SAN ANTONIO WATER SYSTEM
Interdepartmental Correspondence Sheet

Subject: Zoning Case Z2020-10700173 (Verizon Wireless-Kyle Seale North)

ZONING FILE: VERIZON WIRELESS - KYLE SEALE NORTH (FIGURE 1)
 ZONING CASE: Z2020-10700173
 MAP PAGE: 147, D6

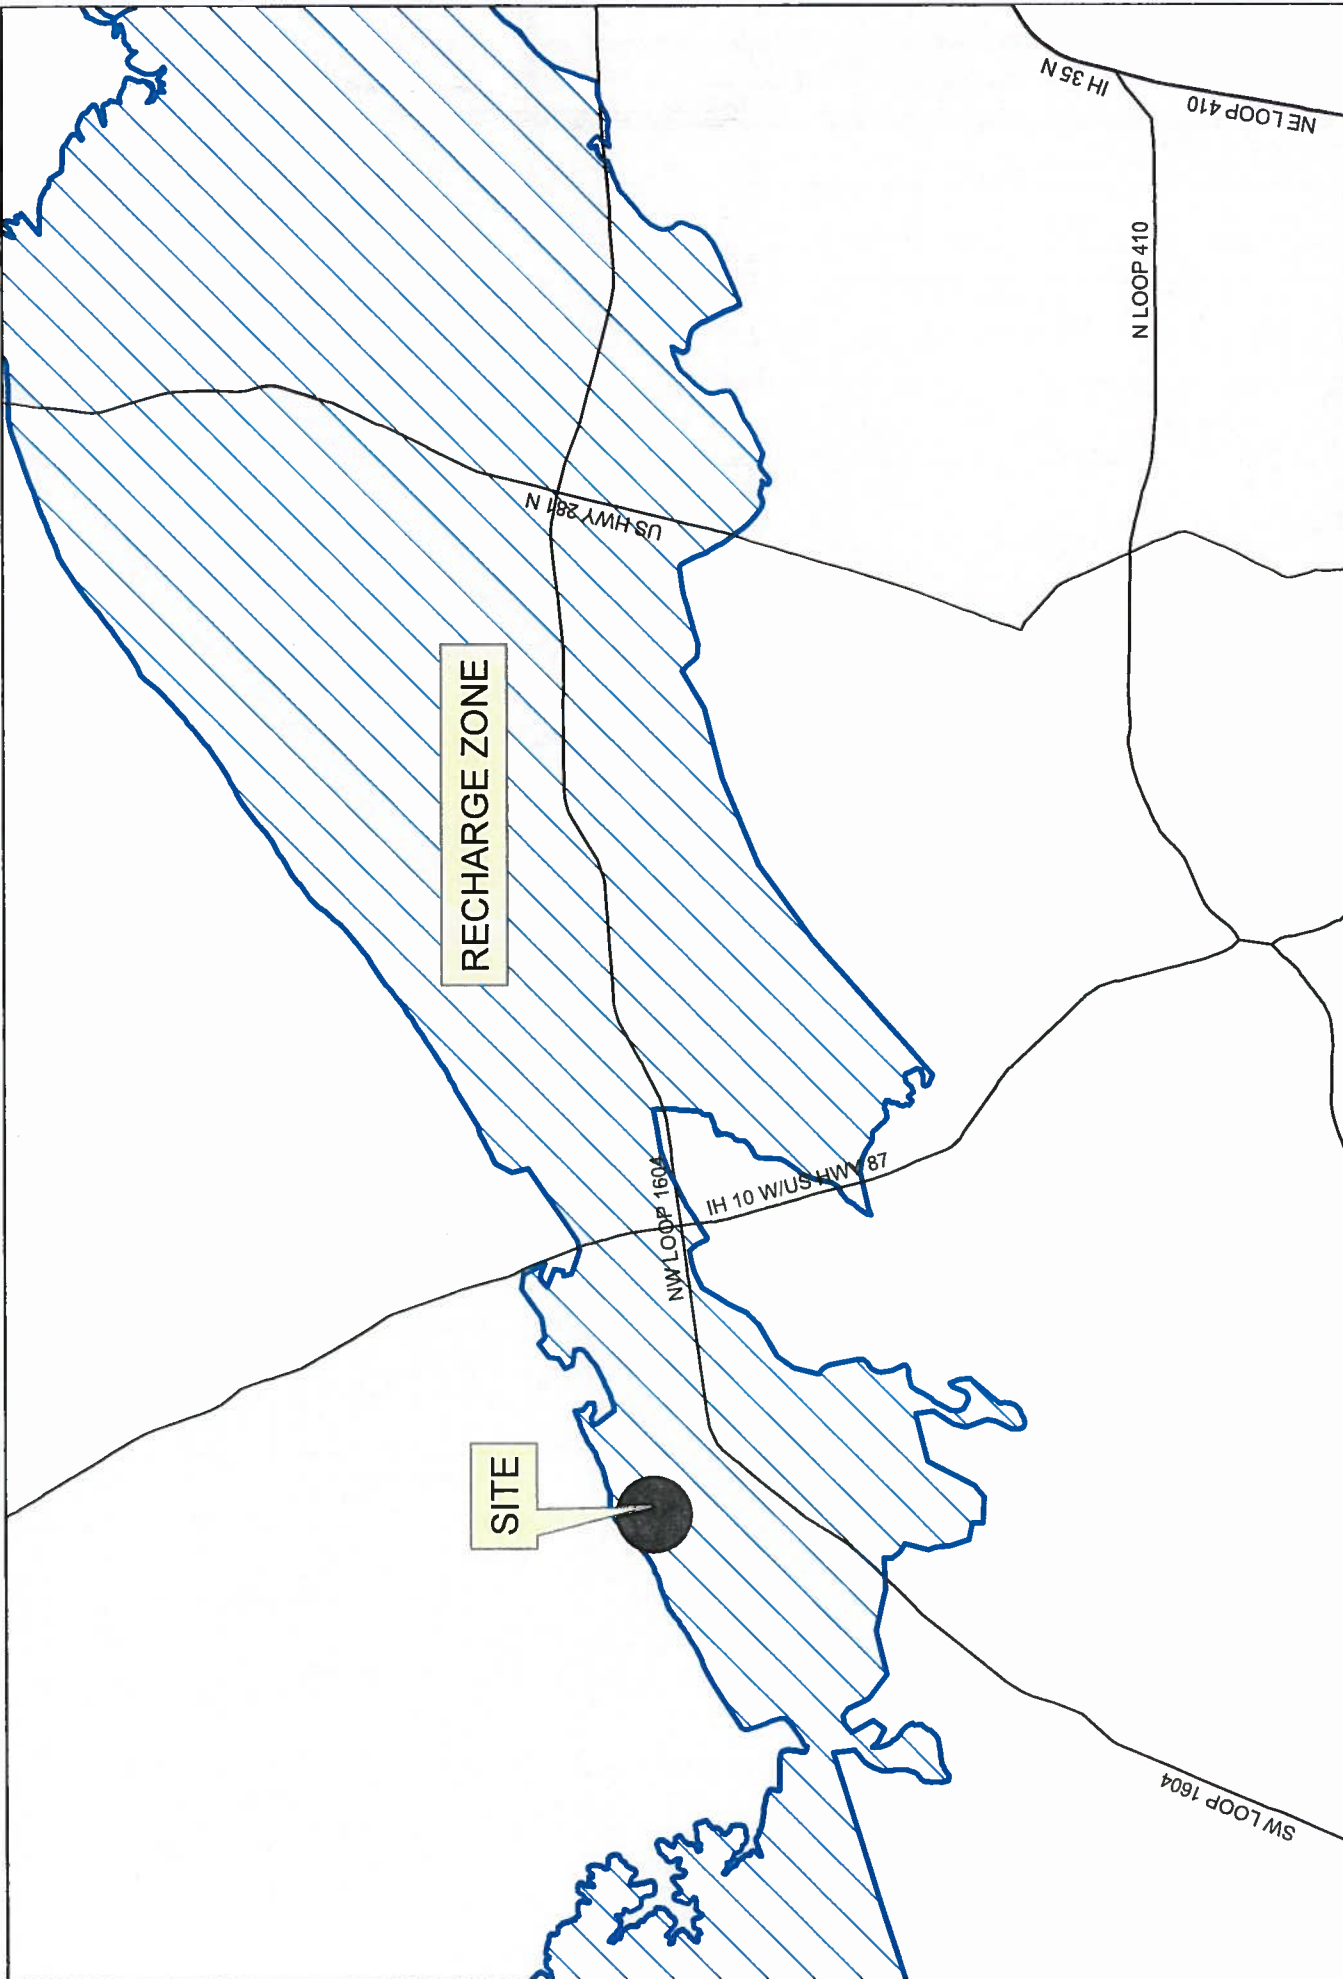
The 0.2809-acre project sits within a 1.52-acre undeveloped site. The subject property is located at 16821 Kyle Seale Parkway. The telecommunication installation will consist of a driveway leading to a 194' self-supporting tower, and equipment cabinets on a 40' x 40' square foot pad site. Stormwater runoff from the driveway and pad site will be treated by vegetative filter strips. According to the U.S. Geological Survey Water-Resources Investigations Report 95-4030, it was determined the site is underlain by the Dolomitic Member of the Kainer Formation of the Edwards Aquifer. No sensitive geologic features were observed on-site, nor identified on file. The property is in City Council District 8, located 1.8-miles north of the intersection of Kyle Seale Parkway and N. Loop 1604 W. The entire property lies within the Edwards Aquifer Recharge Zone. (Figures 1 and 2).
